Subject: Collin County Healthcare Facility, Parking Garage, and Medical Examiners
PCO No. 102; RFI #358 ME Property Room 144 Low Exhaust

Issue No. 102 - RFI #358 ME Property Room 144 Low Exhaust Amount

RFI #358: ME - Property Room 144 Low Exhaust

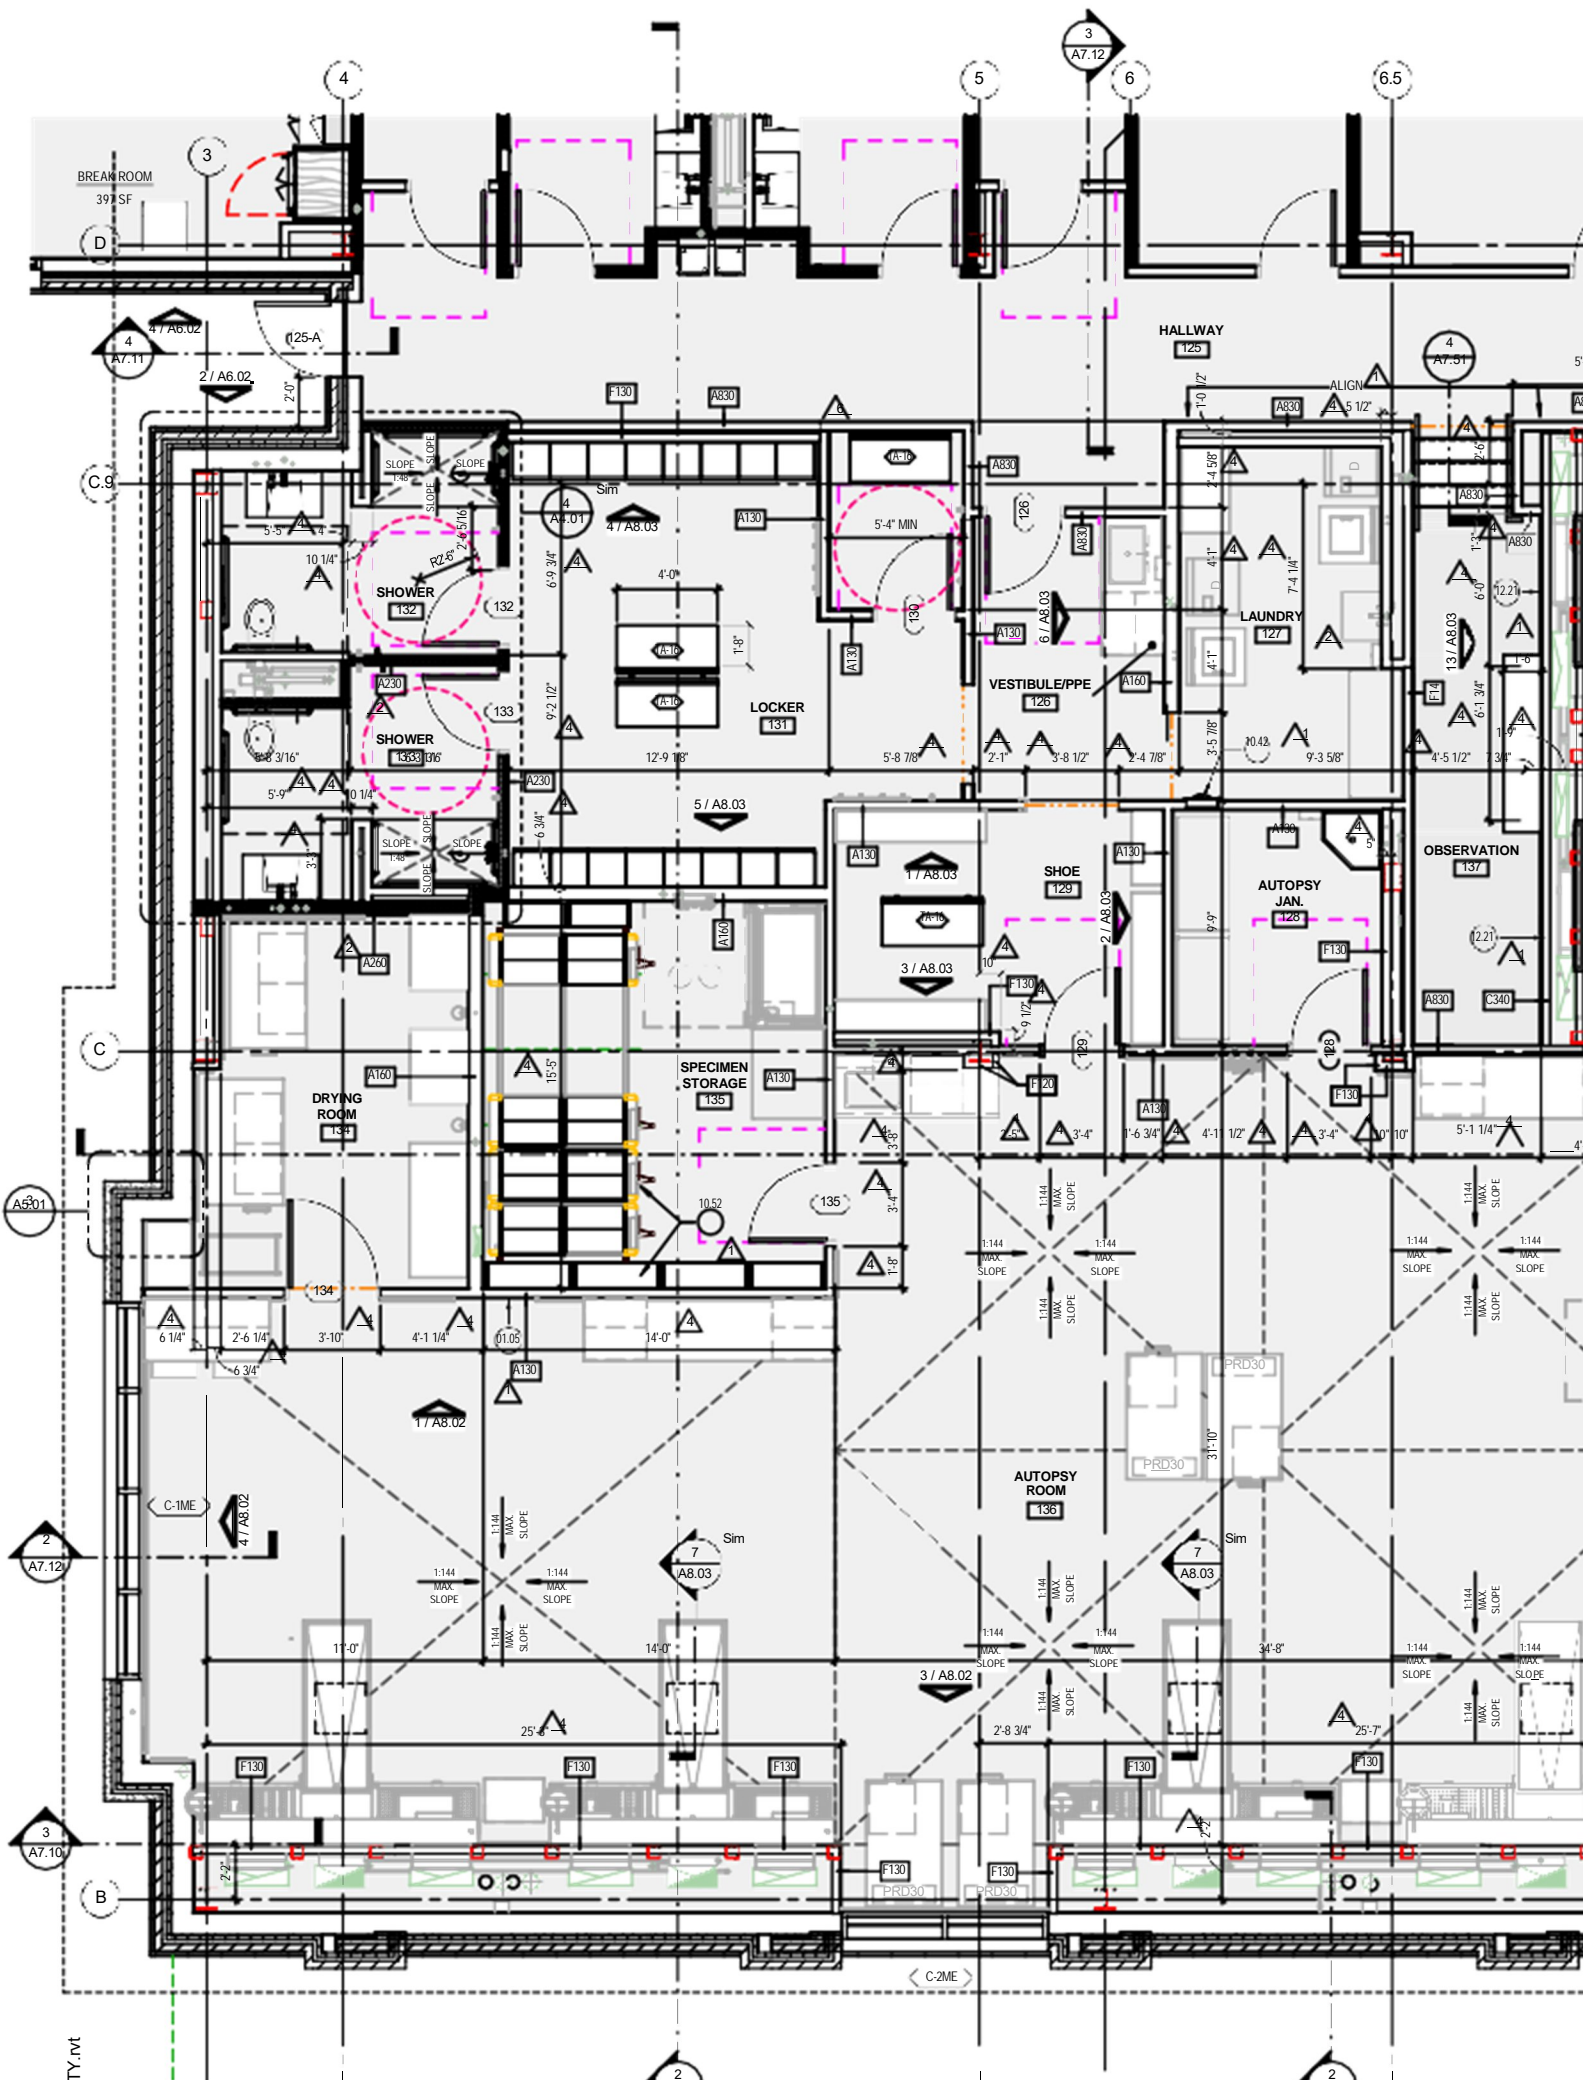
During a recent site walk with the design team, it was noted that the ME property room 144 is missing a low exhaust. The low exhaust is not shown on the mechanical ductwork plan.

Please advise if this low exhaust is needed. If so, please provide updated design drawings to capture this change with keeping in mind the current design constraints of scheduled partition thicknesses, types, casework/shelving, etc.

Low exhaust will be required.

Shift the current 24"x24" ceiling exhaust grille Plan North and balance to 90 CFM (instead of 130 CFM).
Provide new, 4"x8" duct in furr down in corner with a new exhaust grille balanced to 40 CFM. Bottom of grille to be mounted at 12" above finished floor.

Refer to attached image for more information.
